Planning Commission Department of Planning, Housing, and Zoning

AGENDA

Thursday, August 1, 2024 1:30 p.m.

SUBJECT: William and Valerie Ashmore – Major Site Plan – Private Destination/Residence Club

Attachment A – Landscape Planting Plan and Planting Palette

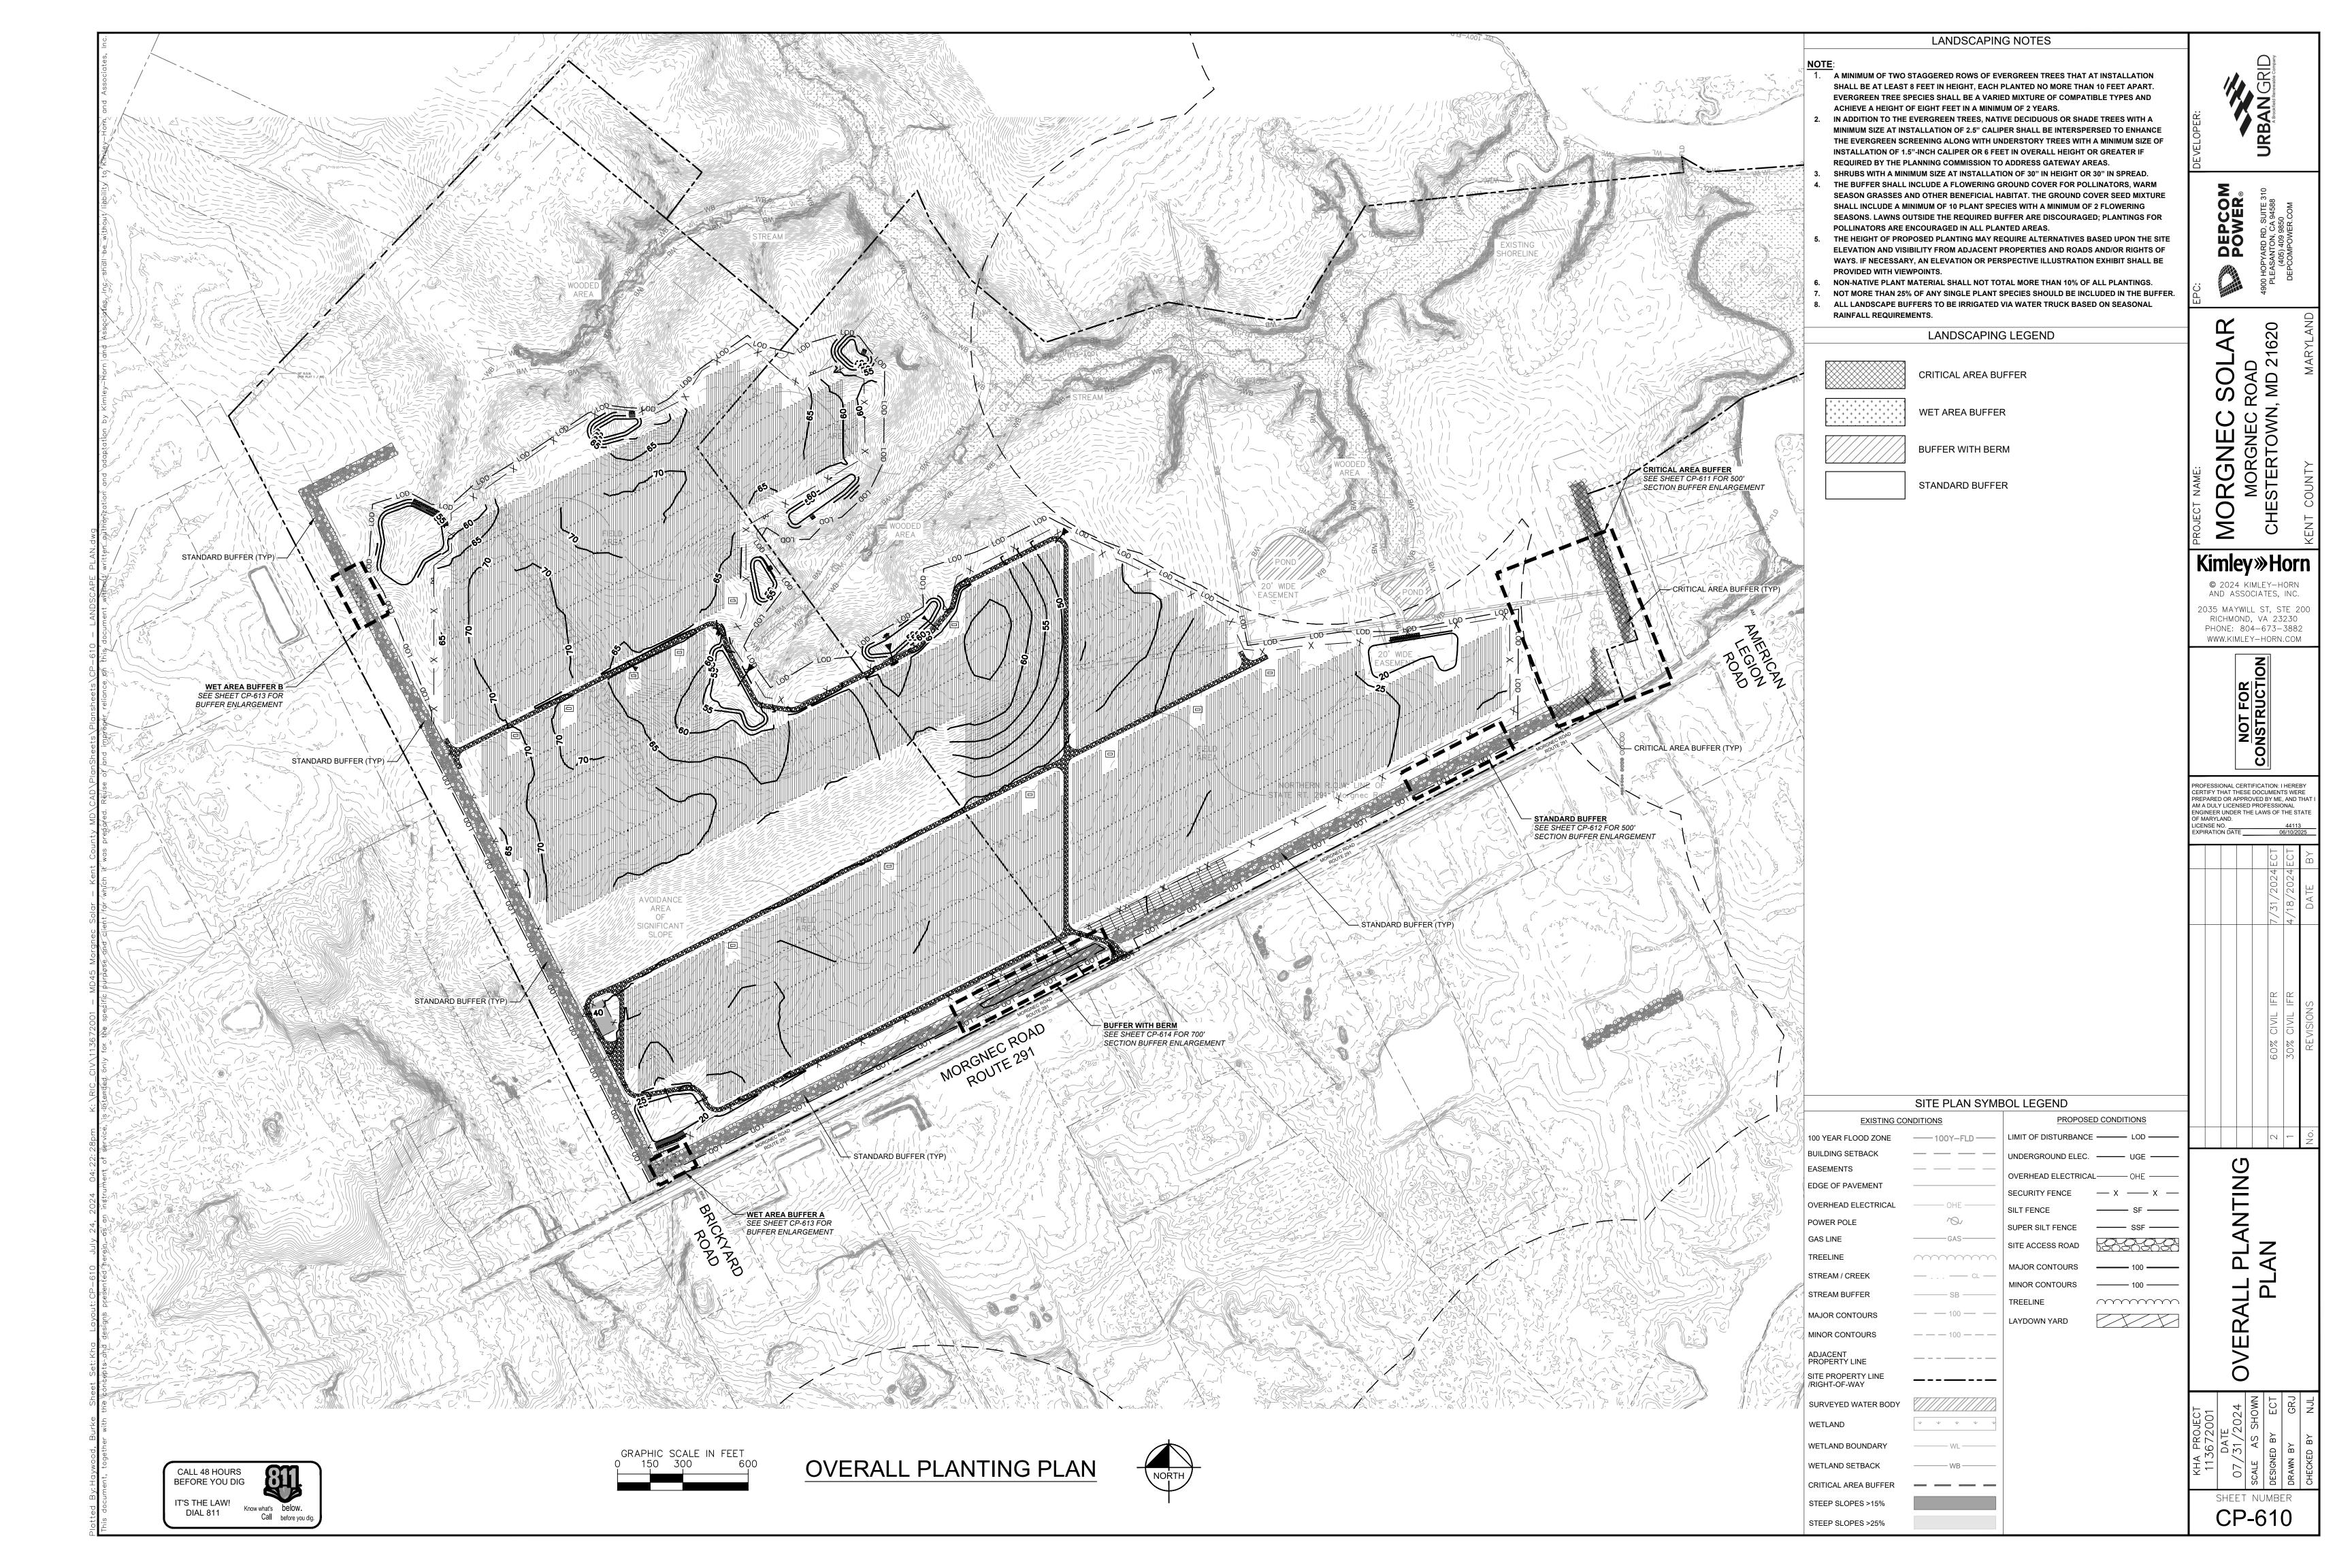
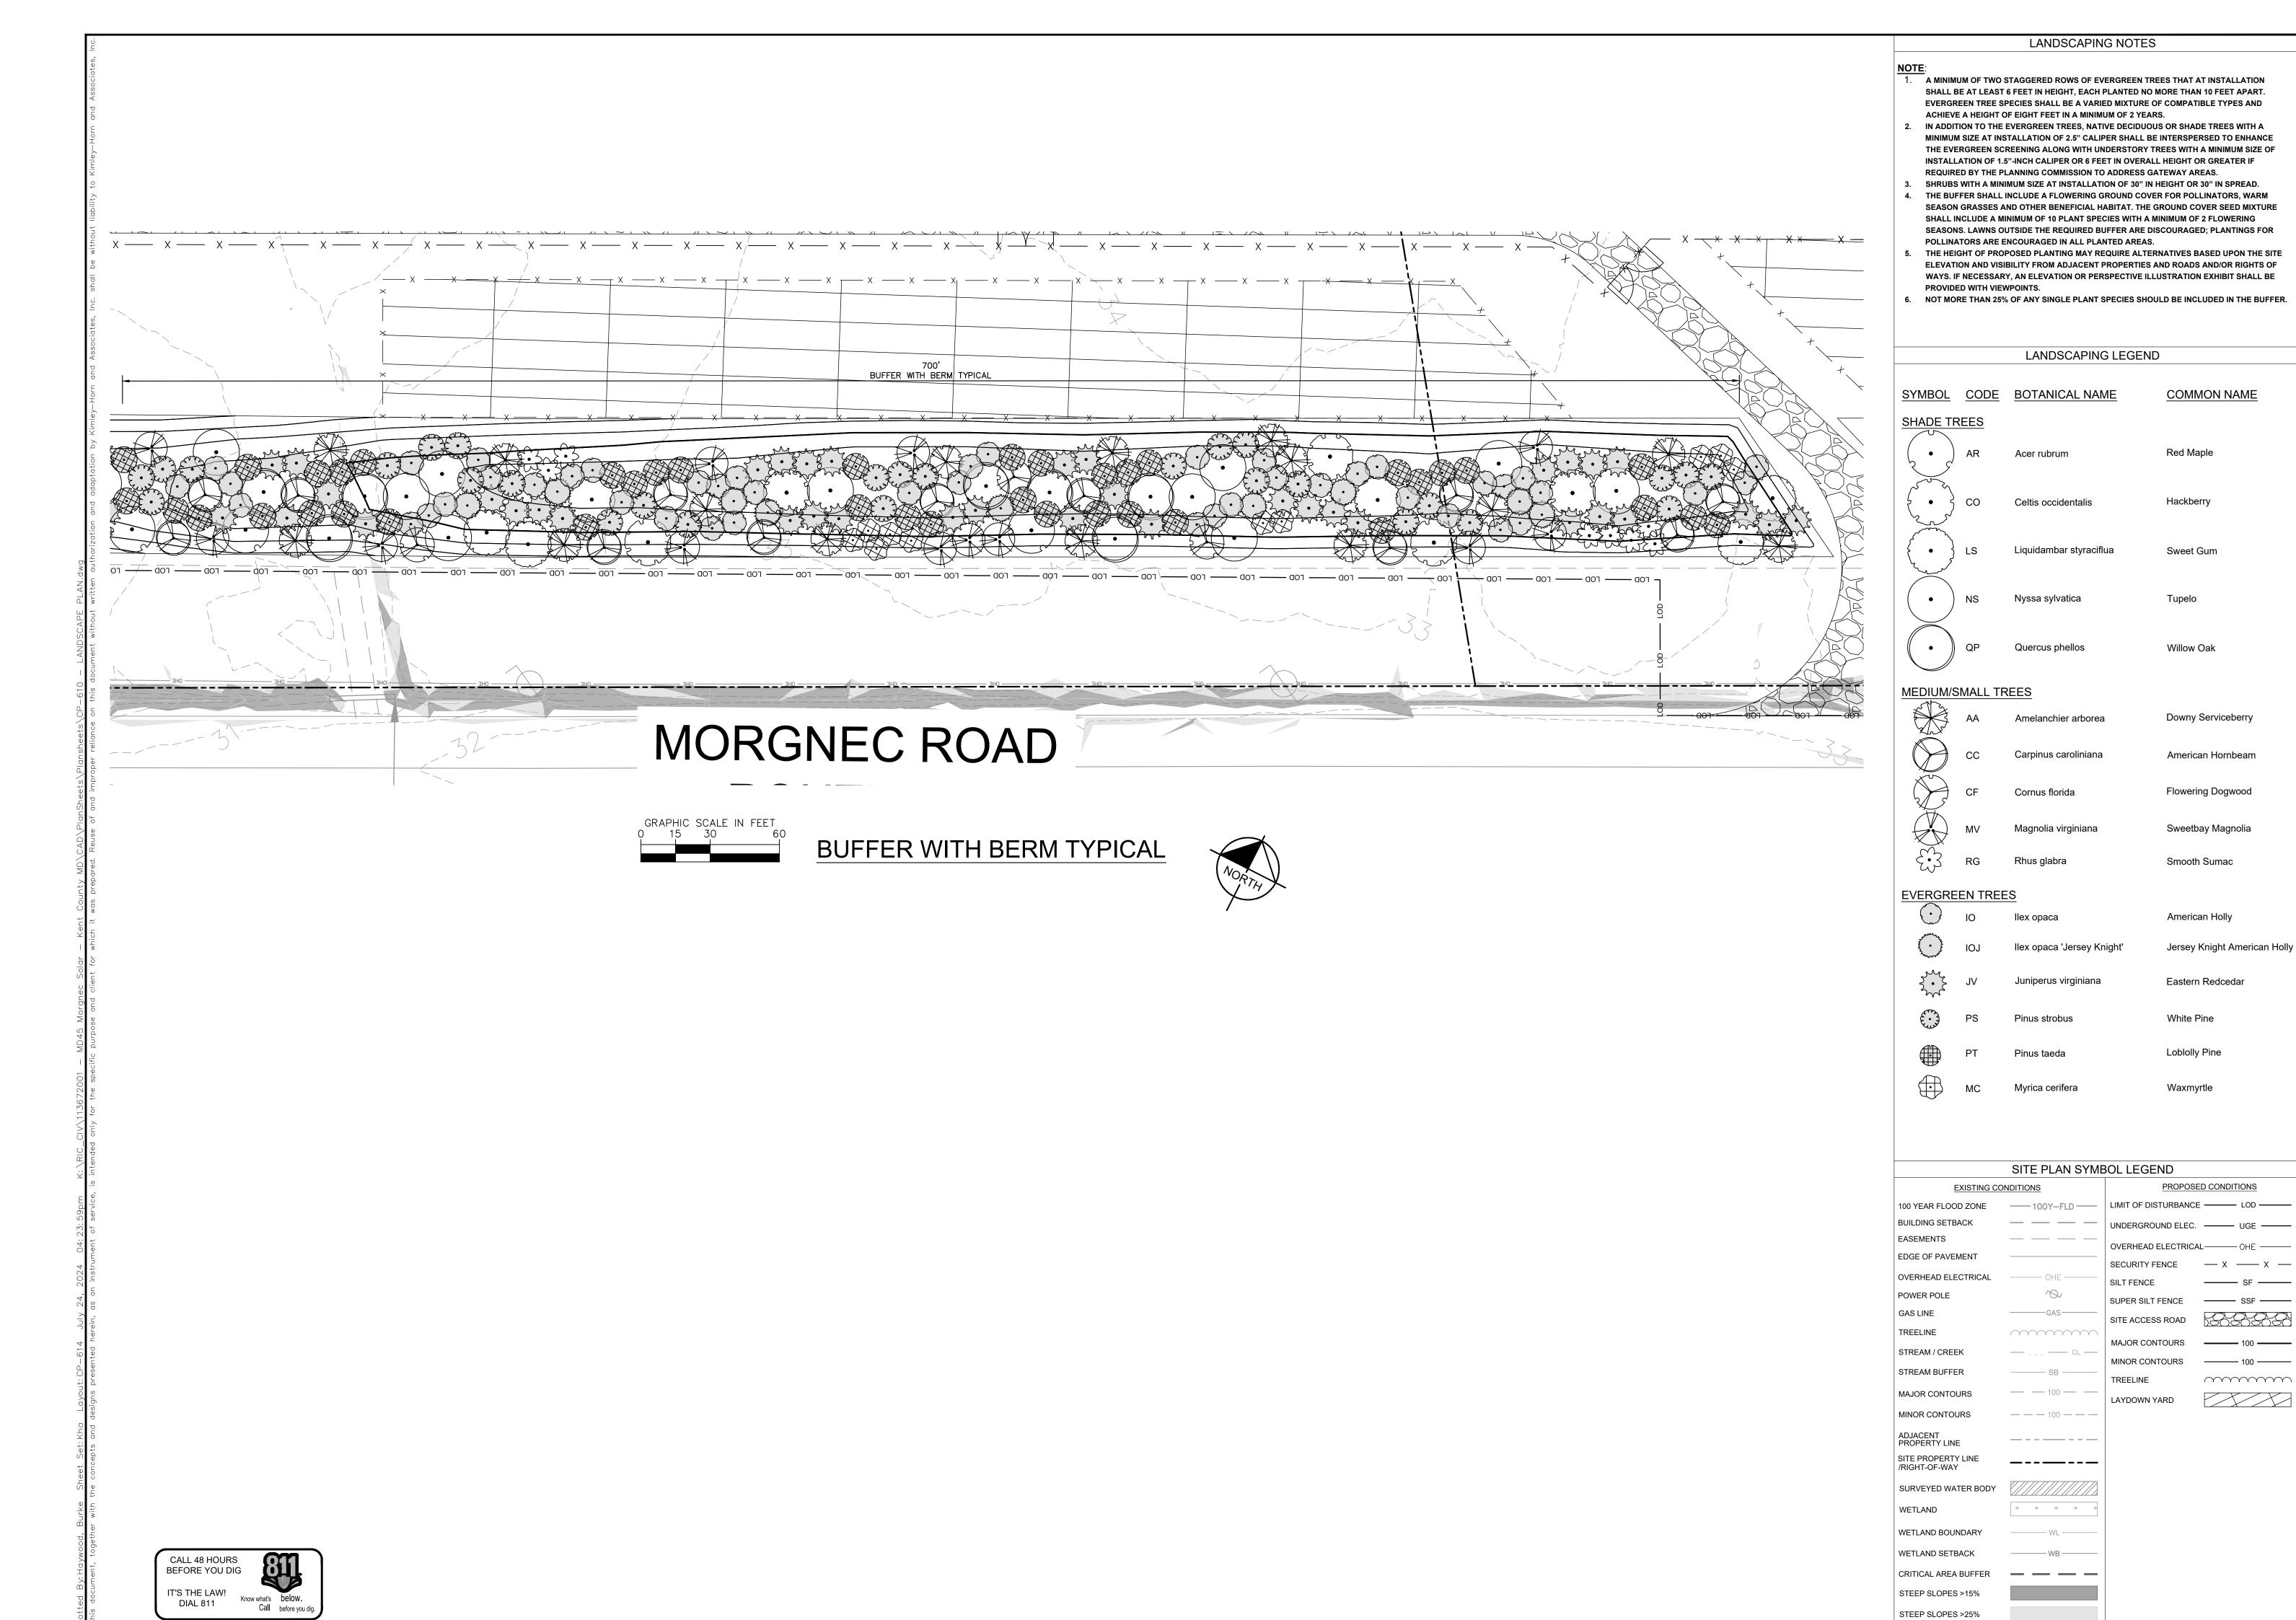
- The submitted landscaping plan (Sheet CP-610) illustrates four planting zones: a hedgerow composed of mixed trees and shrubs to serve as a wind break, a low pollinator meadow around the solar array of grasses no more than 30 inches high to be mowed once annually, a pollinator habitat under the solar array to function as wildlife habitat to be mowed once annually, and a densely vegetated buffer composed of mixed trees and shrubs.
